RTS-TB-029**20-June-2014****RP-1000 Microphone Gating Rework**

RTS[™] TECHNICAL BULLETIN

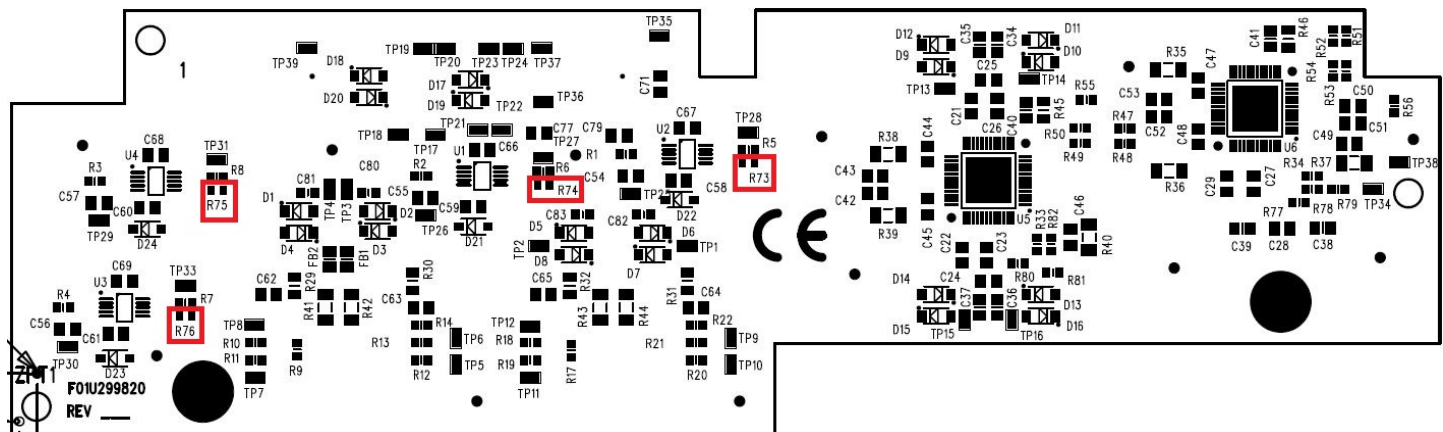
There have been several field complaints from various regions regarding a gating behavior on the RP-1000 microphone circuits (both headset and panel). This behavior was originally seen on early CLD panels before a change was made to a component value in the design. As part of the recent move of the analog PCBAs from one manufacturing facility to another, this change was omitted on RP-1000 builds. As such, an audible gating effect has returned to the microphones on the unit.

In order to address this issue, four resistors need to be replaced on the analog daughter card of the RP-1000. These resistors effectively disable the gating behavior of the analog compression ICs present on all microphone circuits. This returns the behavior to the same performance as the previous CLD panels.

1. Locate gating resistor reference designators R73, R74, R75 and R76 according to the assembly drawing below.

- 4 pieces of 30.1 kOhm 0603 1% 0.1W resistor (Bosch part number F.01U.013.116, F.01U.164.192 or equivalent)

2. Remove and discard the existing resistors located at locations R73, R74, R75 and R76.
3. Solder the 30.1 kOhm 0603 1% 0.1W part (F.01U.013.116 or equivalent) onto R73, R74, R75 and R76.
4. Re-assemble PCBA into RP-1000 and re-test for proper operation.
